Varsity Lincoln Display Lot JSP13-67

Public hearing at the request of Varsity Lincoln Properties, Preliminary Site Plan, Special Land Use Permit, and Stormwater Management Plan approval. The subject property is 1.57 acres in Section 17 of the City of Novi and located on Outlot 1 of the larger Novi Promenade development on the southeast corner of Wixom Road and Grand River Avenue. This property is part of the Novi Equities Limited Partnership v. City of Novi Consent Judgment which states that all outlots should be reviewed according to B-3 District standards. The applicant is proposing to construct a roughly 49,100 square foot vehicle display lot, including a vehicle display pad at the southwest corner.

PLANNING REVIEW

**SUBJECT: Varsity Lincoln Display Lot, JSP13-0067,
Traffic Review of Revised Preliminary Site Plan, PSP13-0165**

**UNDERGROUND STORM
DETENTION SYSTEM DETAIL** A
N.T.S. C4.0

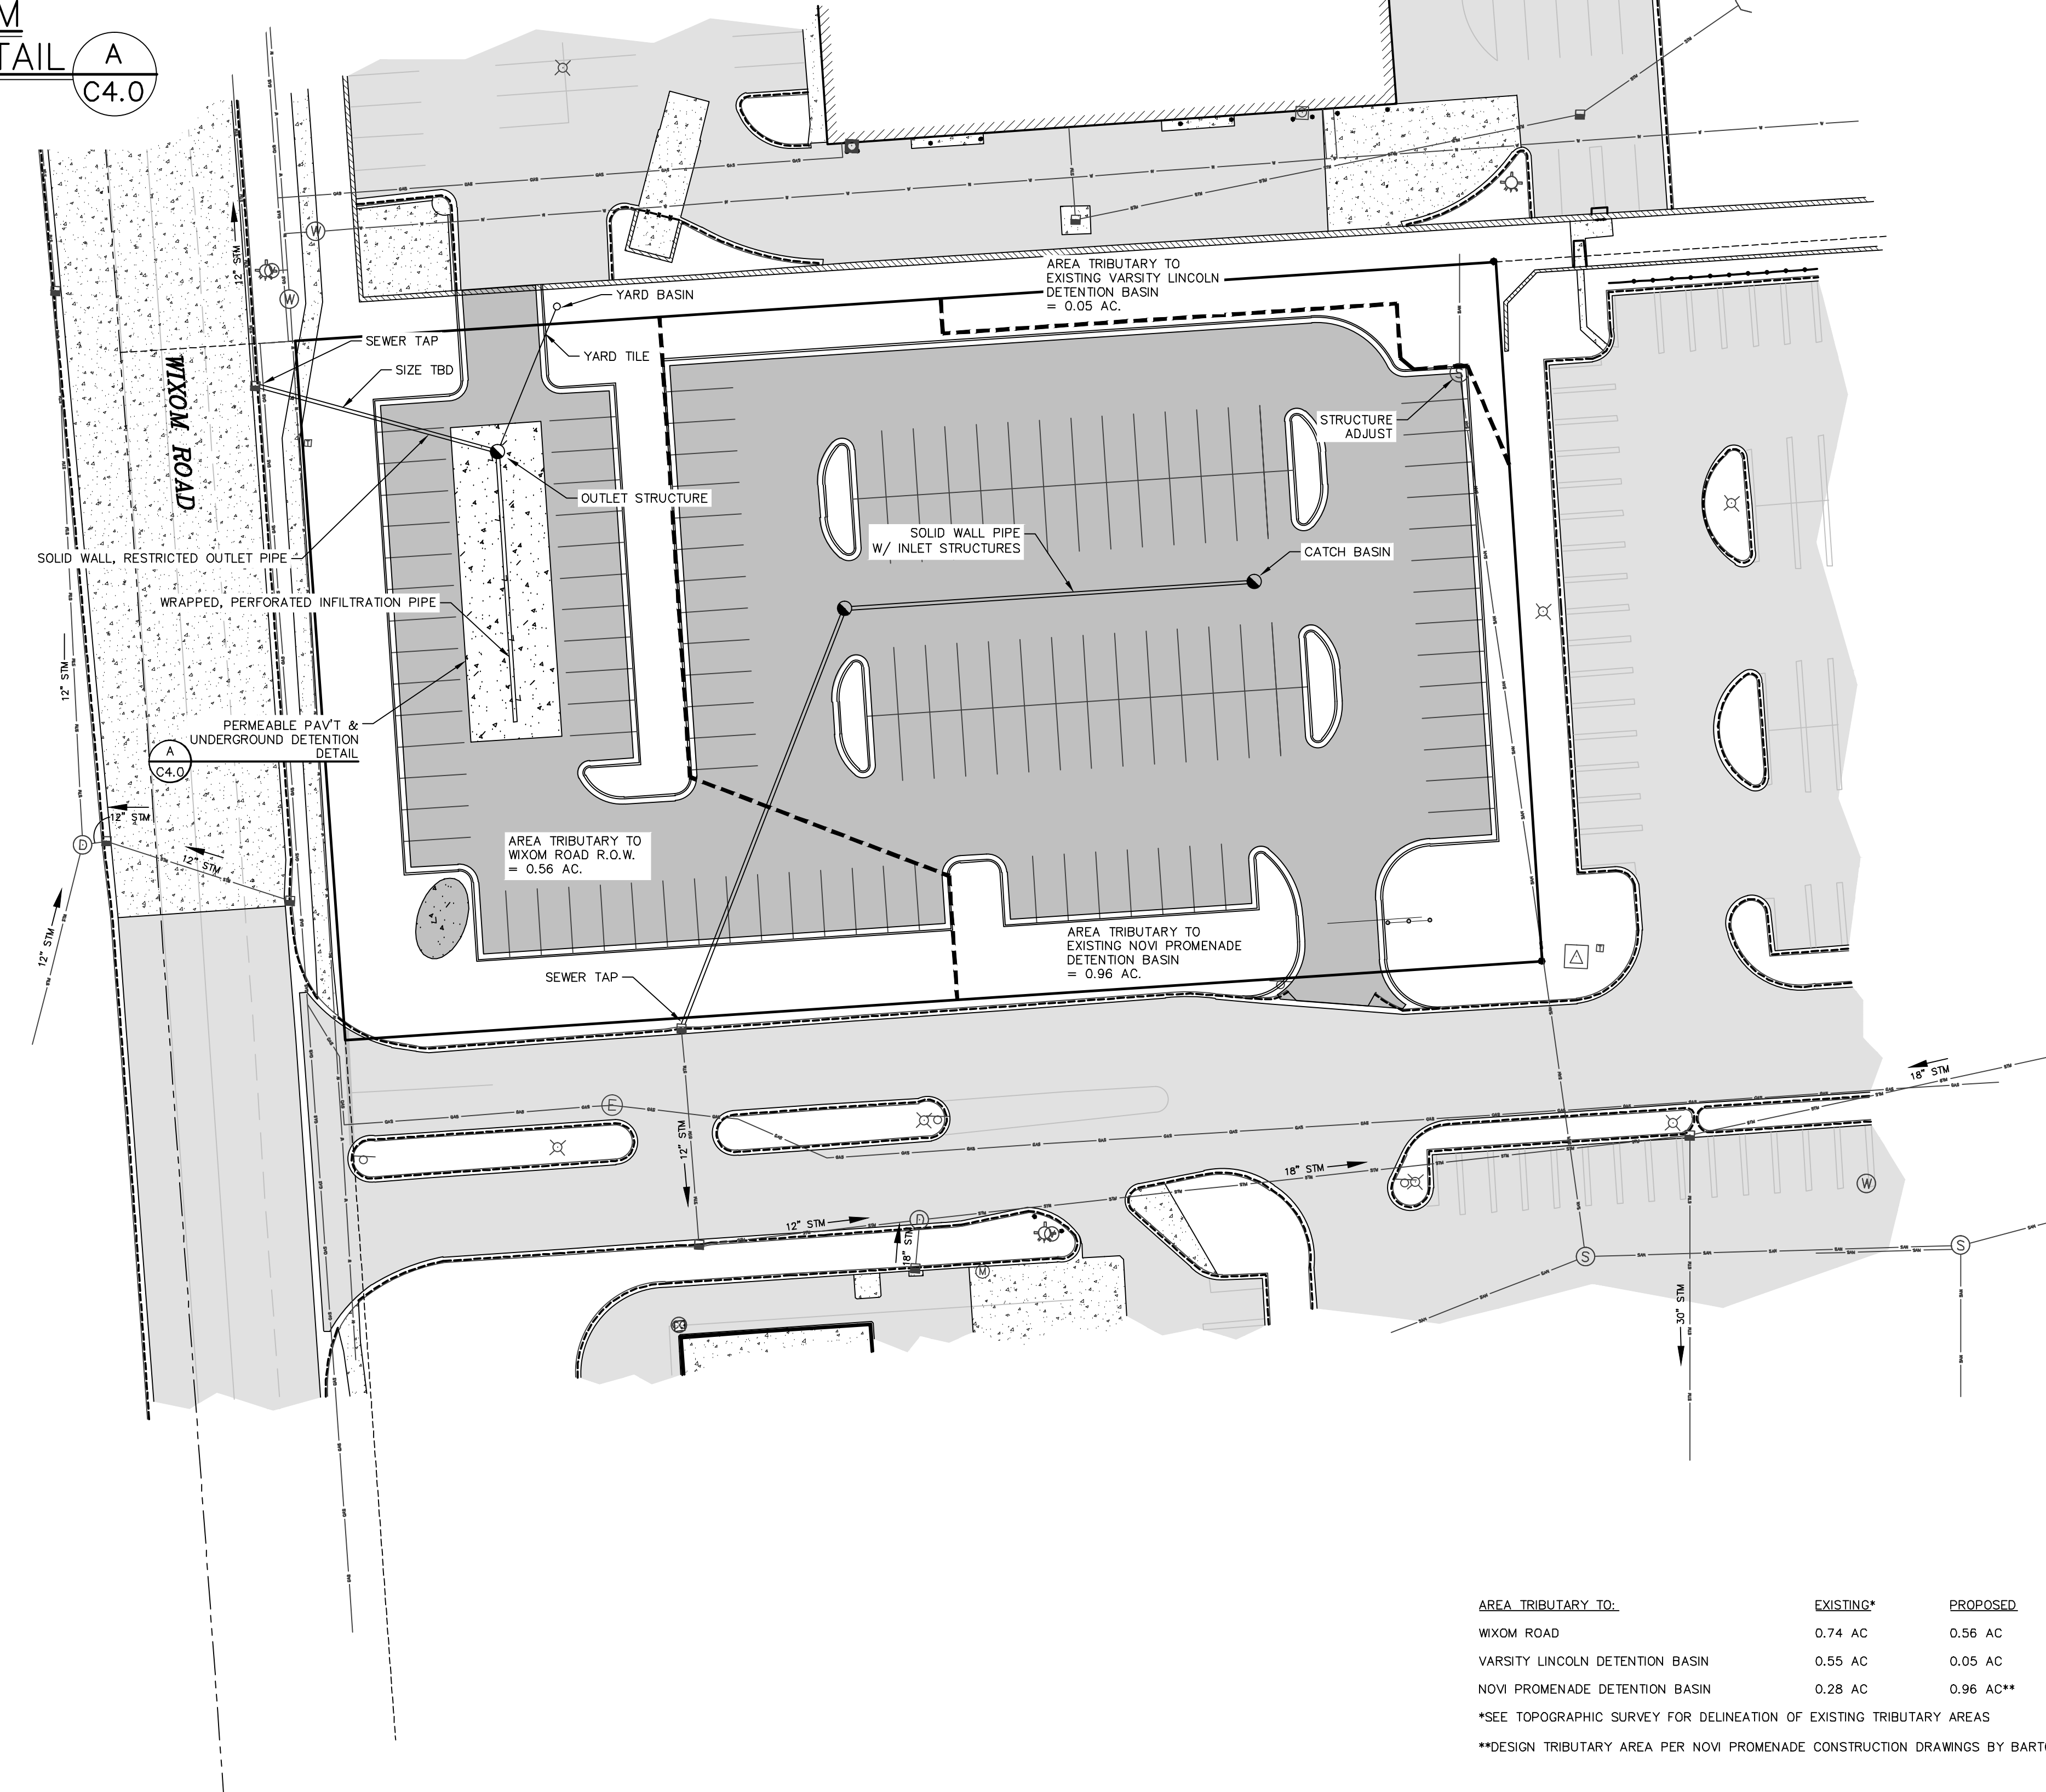
3. Provide an inlet structure for the proposed underground detention system.
4. Provide an oil/gas separator at the last structure prior to discharge into the underground detention system.

7. Provide manufacture specifications for the proposed underground detention system including material type, size, bedding requirements, and any other applicable information.

8. Provide a detail for the underground detention system's outlet control structure. This structure shall be designed to detain the first flush, bankfull, and 100-year storm event volumes.

10. Provide critical elevations (bankfull and 100-year storm hydraulic grade lines) on the underground detention system cross-section demonstrating that the detention system is 3 feet above ground water and has the required 1 foot of freeboard between the high water elevation and the subgrade below the pavement.

Items 1-22 will be addressed on the Site Plan Stamping Set Submittal
Items 23-30 will be addressed prior to construction

PROPOSED PHOTOMETRIC PLAN
Scale 1" = 20'
1

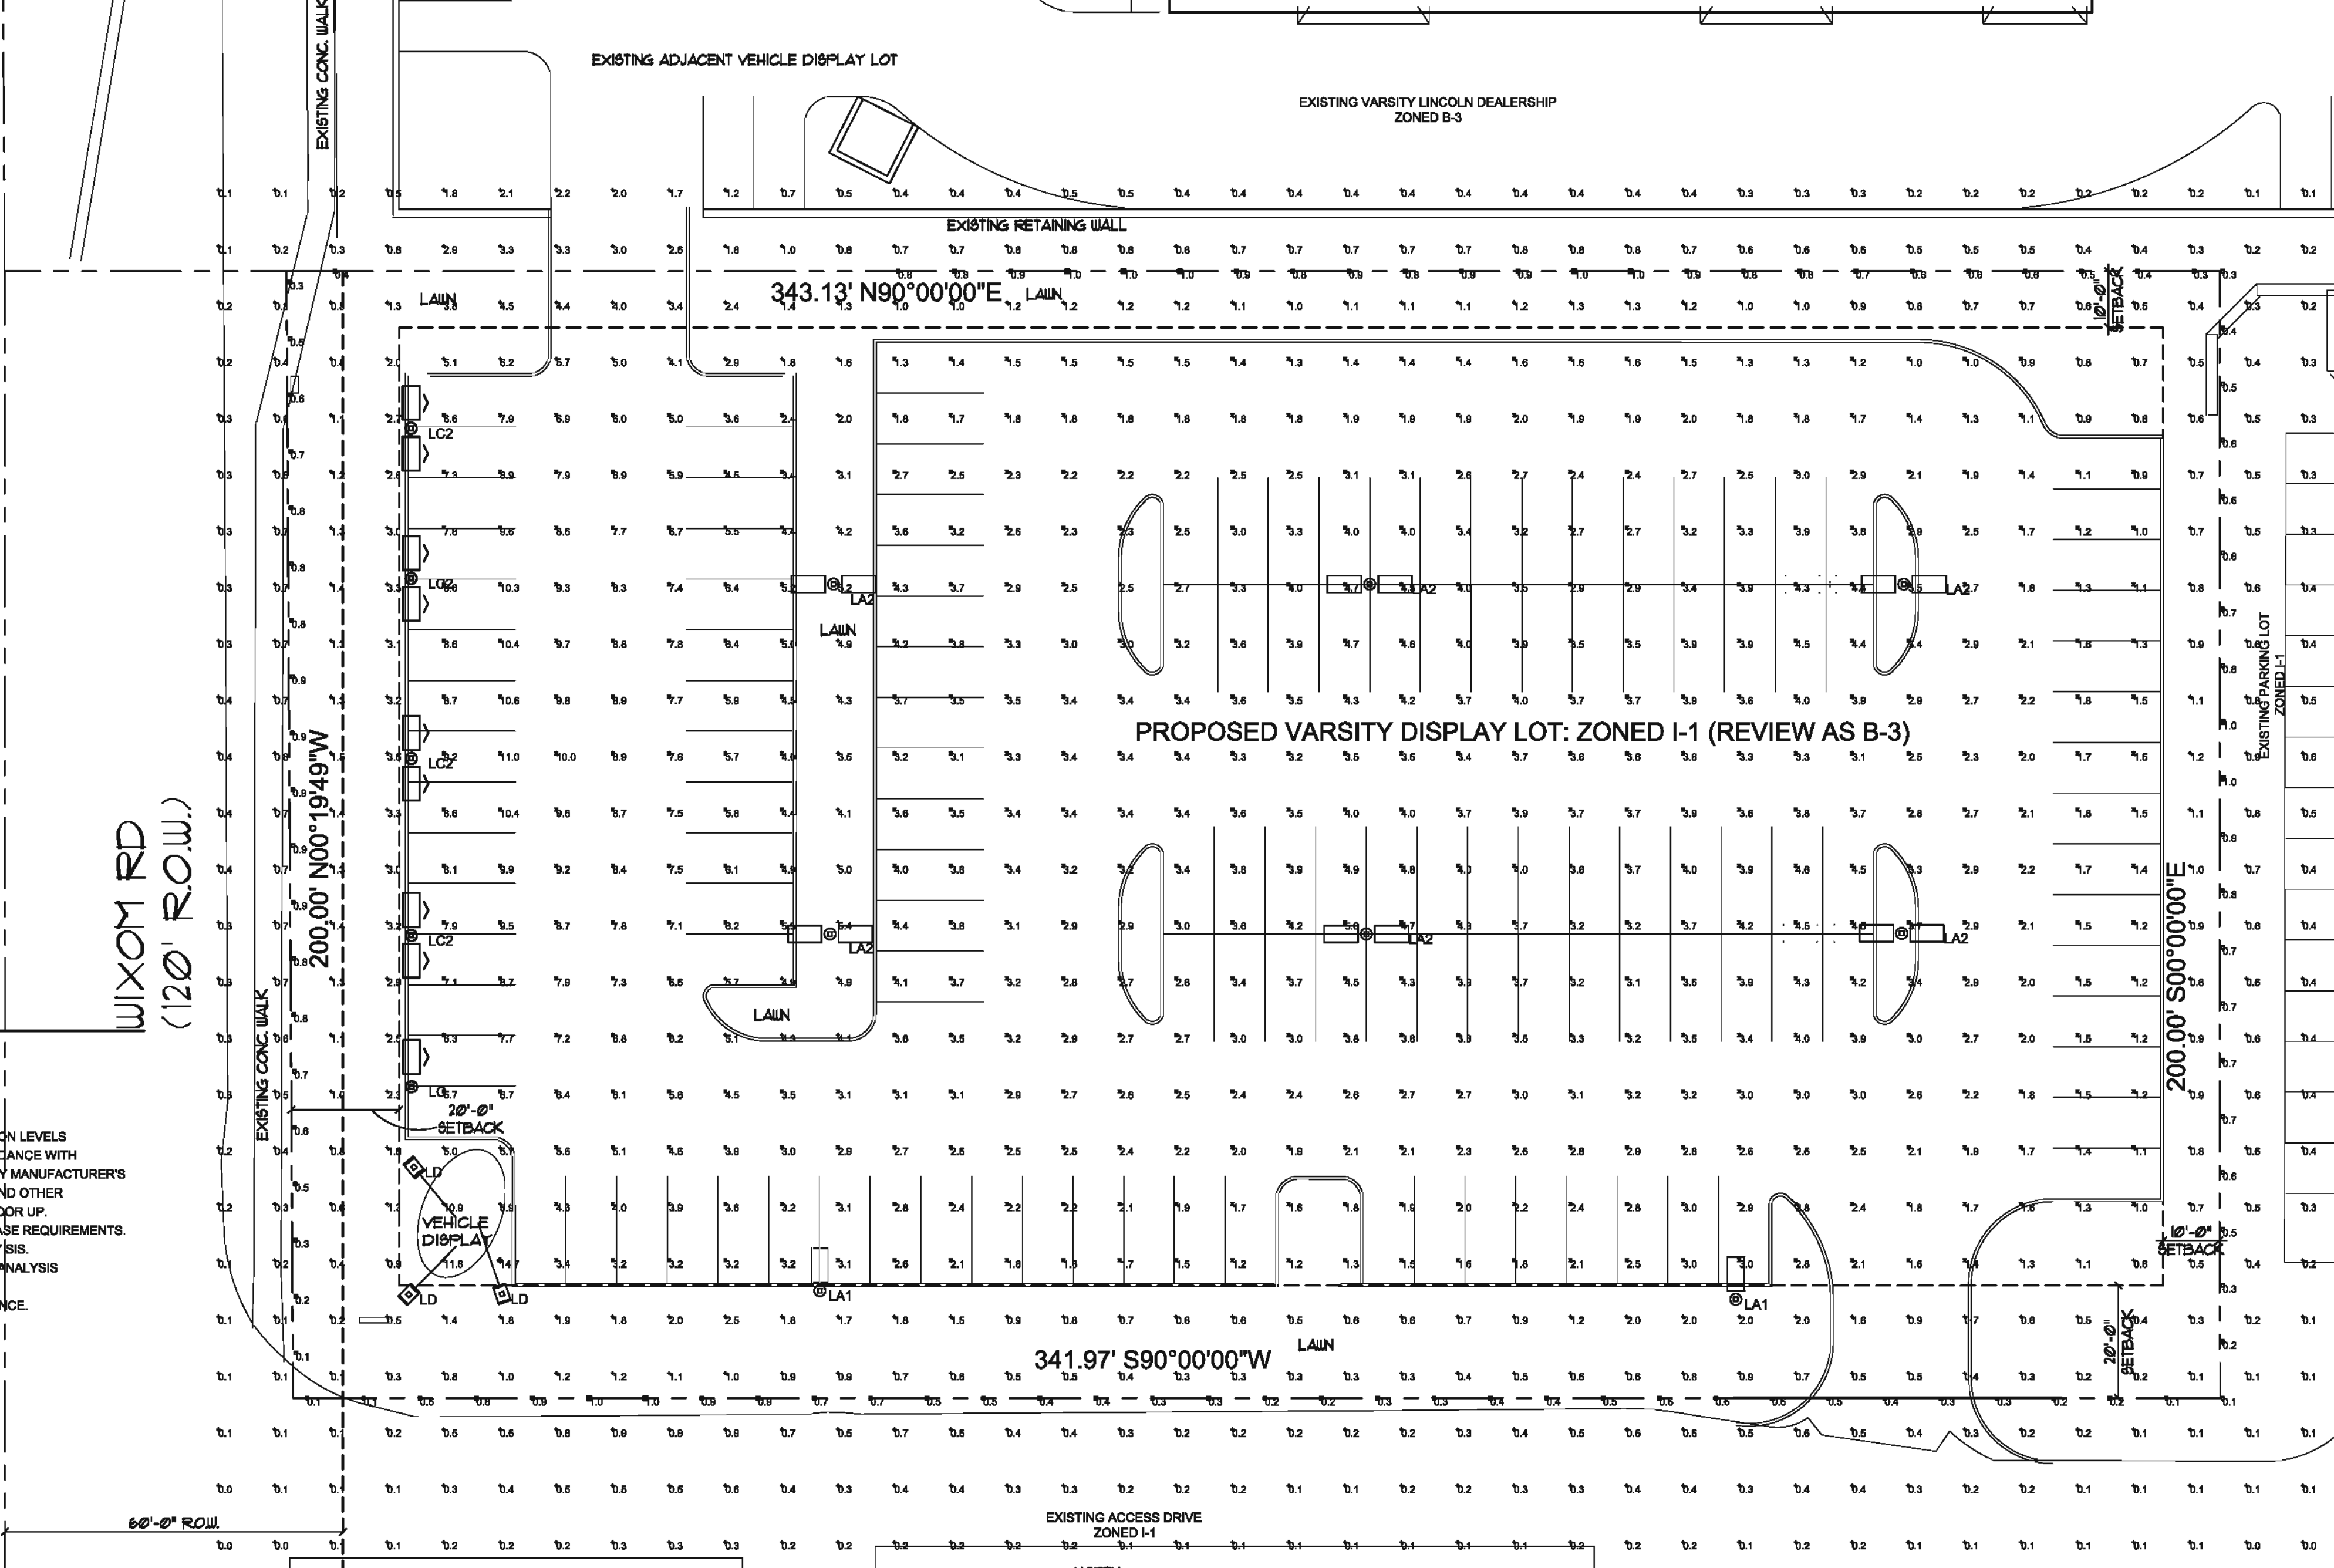
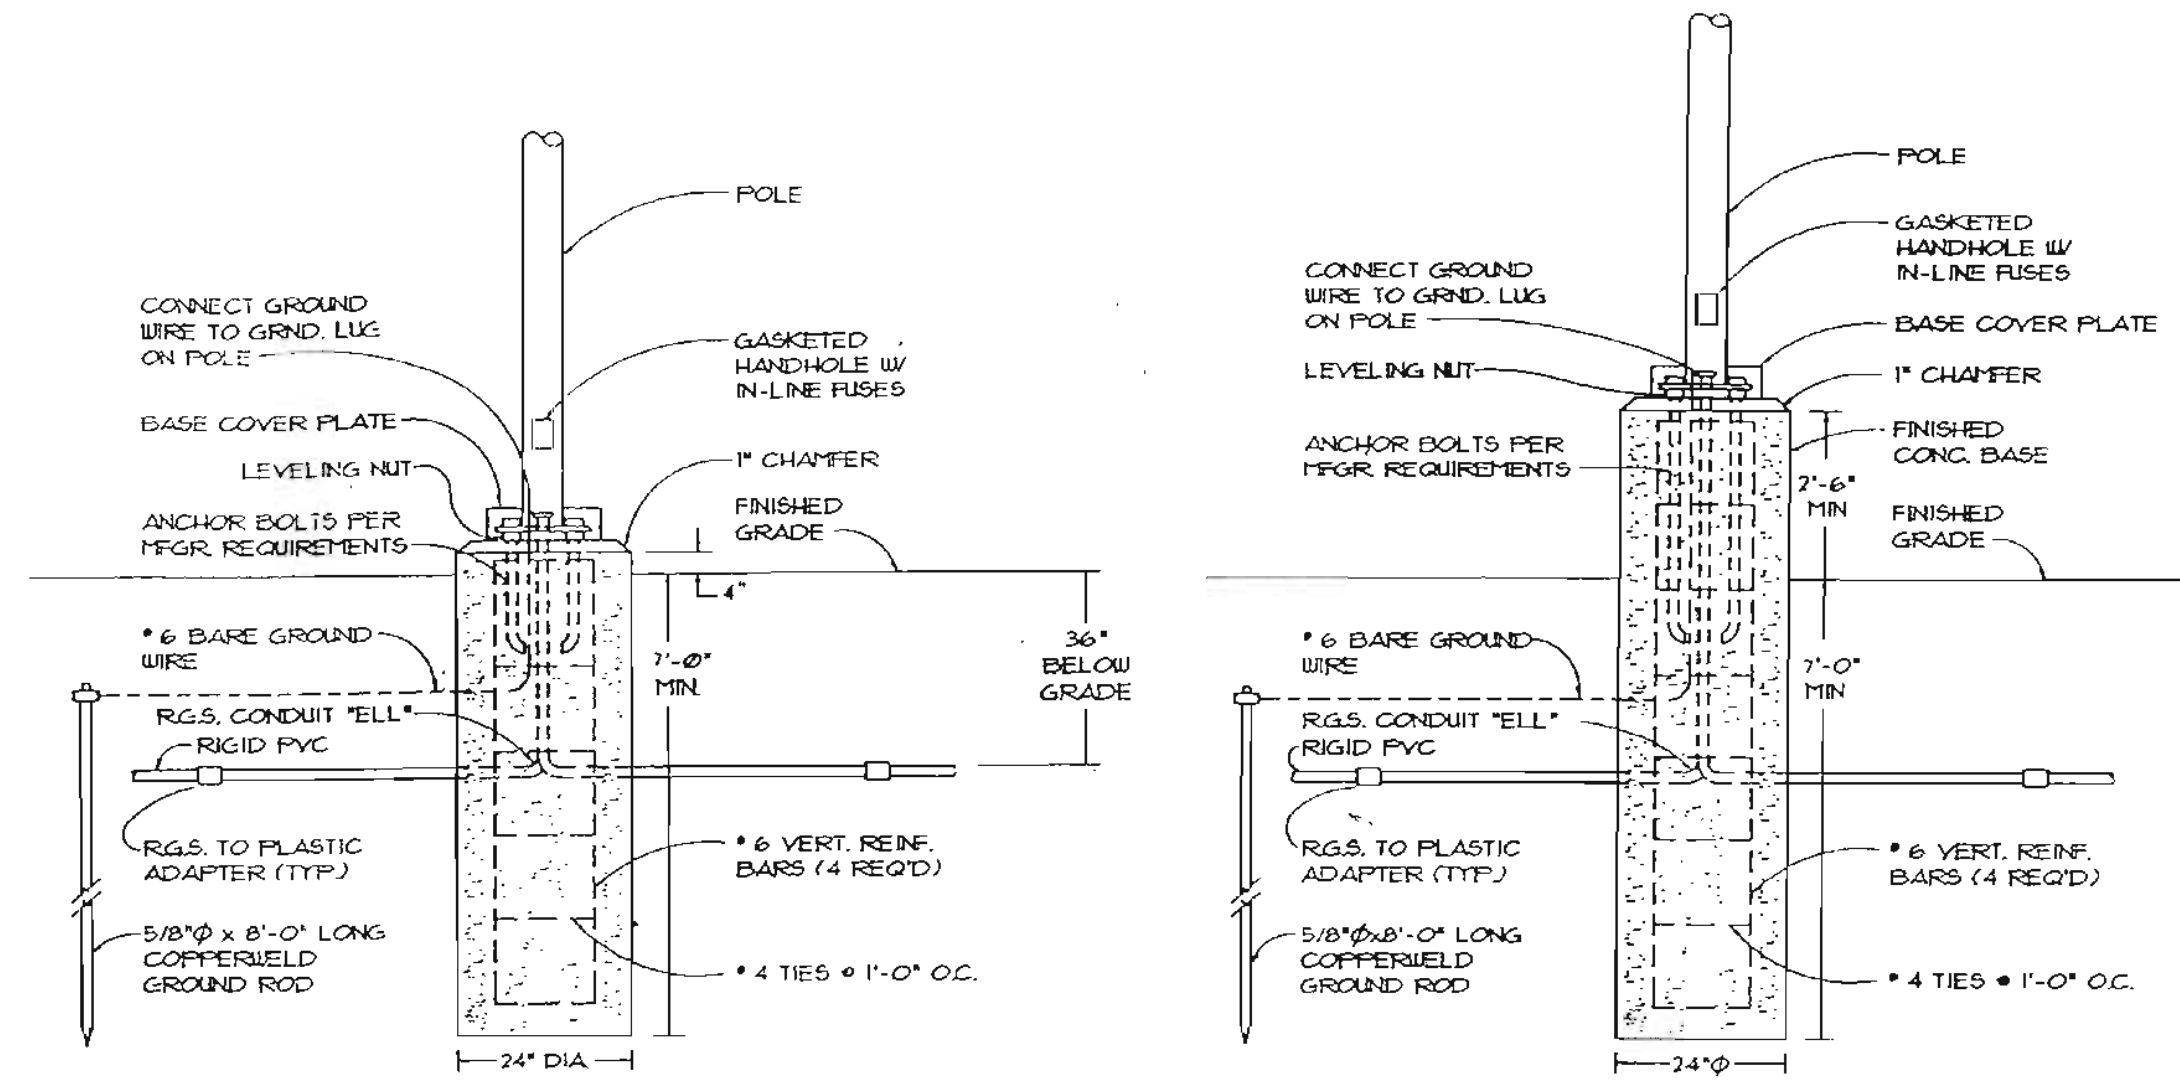
2. Photometric Plan: There are a couple of items missing on the photometric plan. **The applicant should revise the photometric plan to comply with the requirements noted in the lighting review chart.**
3. Sidewalks: As discussed with the applicant previously, **the Planning Division continues to recommend the applicant install a 5 ft. wide sidewalk along the existing access drive.**
4. Property Combination: The Planning Division continues to recommend that the applicant pursue a lot combination with the property to the north to assemble the two lots into one for development purposes.
5. Signage: Exterior Signage is not regulated by the Planning Division or Planning Commission. Please contact Jeannie Niland (248.347.0438) jniland@cityofnovi.org or for information regarding sign permits.

| Item | Required | Meets Requirements? | Comments |
|--|---|---|--|
| Required Notes (Sec. 2511.3.b) | - Electrical service to light fixtures shall be placed underground - No flashing light shall be permitted - Only necessary lighting for security purposes and limited operations shall be permitted after a site's hours of operation | Additional information must be provided | All required notes must be indicated on the plans |
| Required Conditions (Sec.2511.3.e) | Average light level of the surface being lit to the lowest light of the surface being lit shall not exceed 4:1 | Additional information must be provided | Average light level for the site must be indicated on the plans |

Sheet L-3 (Lighting Plan) was provided on 10/8/13 as part of the Preliminary Site Plan approval resubmittal. Note that Item Lighting Plan (Sec. 2511.2.a.2) meets requirements according to Lighting Review Summary Chart.

The photometric plan will be updated to include the notes mentioned above.
